**King's Residences  
15 King Street,  
Peabody, MA**

Weston & Sampson has reviewed the plans prepared by Khalsa Design Inc. for the proposed King's Residences development. We recommend the following revisions:

The Horsley Witten Group, Inc. (HW) is pleased to provide the Peabody Zoning Board of Appeals with this letter report summarizing our initial technical peer review of the residential development proposed at 15 King Street, Peabody, Massachusetts. The Comprehensive Permit application for the King's Residences development was prepared by the Panos Law Group on behalf of the Applicant, HDG King Street, LLC. The proposed development includes three (3) multi-family, apartment style buildings with 135 residential condominium ownership units. The existing previously developed site is 3.12 acres and contains a vacant hospital building, a support building, and associated parking lot. It does not appear that the site contains any wetland resource areas or buffer zones to resource areas.

Image 1: Results of 2020 Flow Isolation.

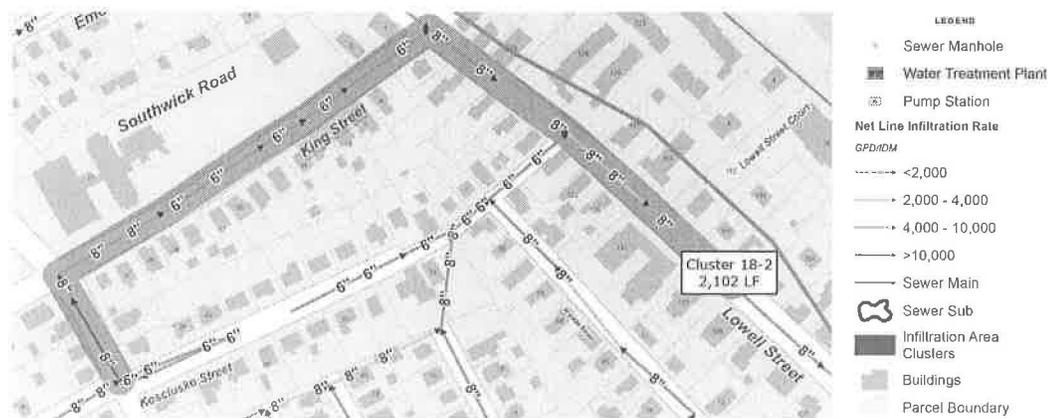
4. The highest flow segment on Lowell Street, shown on Table 1 above, was identified as having infiltration flows of 4,000 to 10,000 gpd per inch-diameter mile (idm) during the 2020 I/I flow isolation and manhole inspection program. The next downstream segments also were found to have infiltration flows over 2,000 gpd per idm during this program. Upstream of the proposed development there is a high infiltration (>10,000 gpd/idm) segment. See image provided below.
